The Staff Report correctly identifies that the zoning history for this property is incomplete at best. The report states: “According to sales records on the Coos County Assessor’s website, the property was purchased by the current owner in September of 1989. When purchased, it appears the property was zoned Controlled Development 1.”

The zoning history of the parcel up to date is no less vague. The Staff Report notes an inability to locate any records that explain the current mixed R1 and NR zoning shown on the City’s official zoning map. This is the most accessible public reference to zoning in Bandon and has existed in its current form since 2009. The 2025 Coos County Tax map conflicts with Bandon’s Zoning Map, showing the property still zoned CD-1, in common with much of the surrounding area including Ocean Terrace phases II and III. In a previous communication with the City, I was informed that they could offer no explanation for a portion of the property being zoned as Natural Resources “aside from its proximity to Johnson Creek”. Oftentimes, the simplest explanation is also the best explanation.

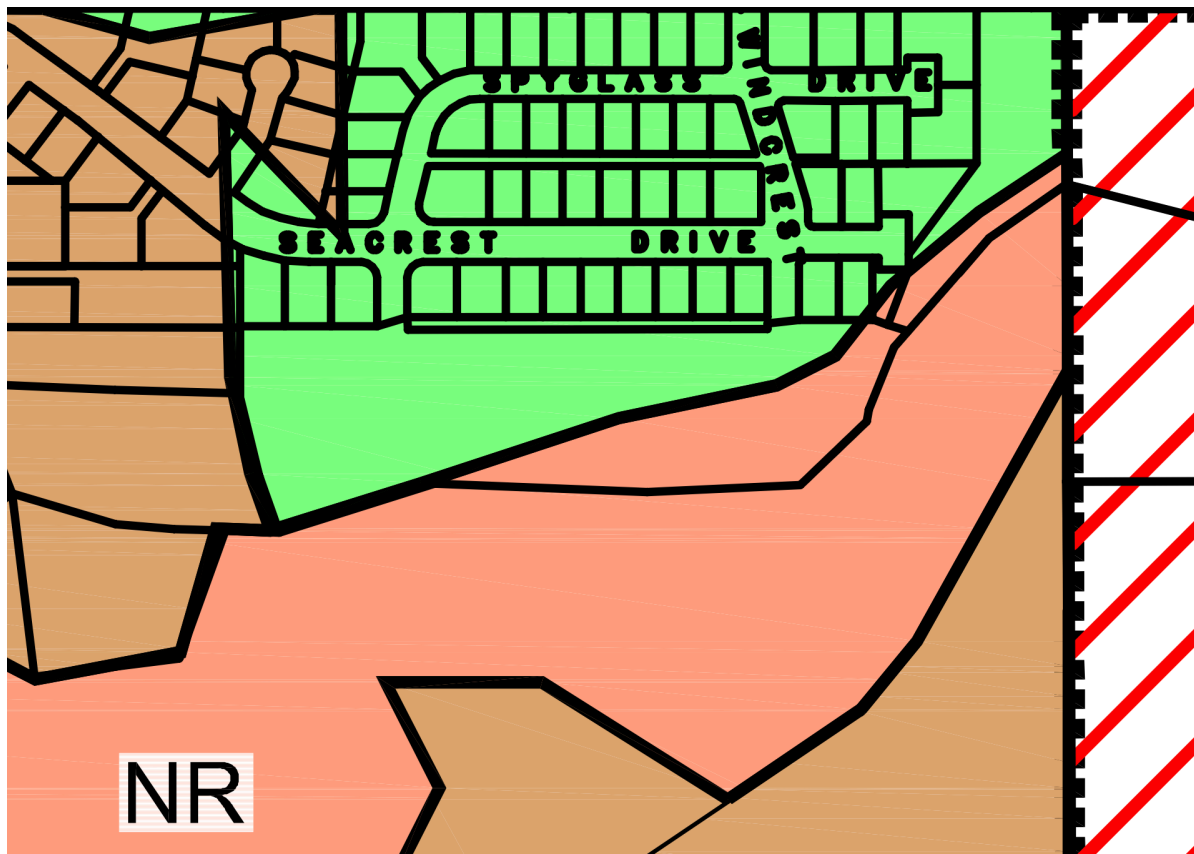
The Staff Report advises that “the City may wish to consider the suitability of the site in terms of slope, geologic hazard, or impact to Johnson Creek.” It is further noted that “the landslide susceptible area is focused along the bluff-edge, on the south and east section of the property.” A

comparison between the Hazard Map and the City Zoning Map shows that the area of high landslide susceptibility extends to the edge of the NR zone in the eastern section of the property.
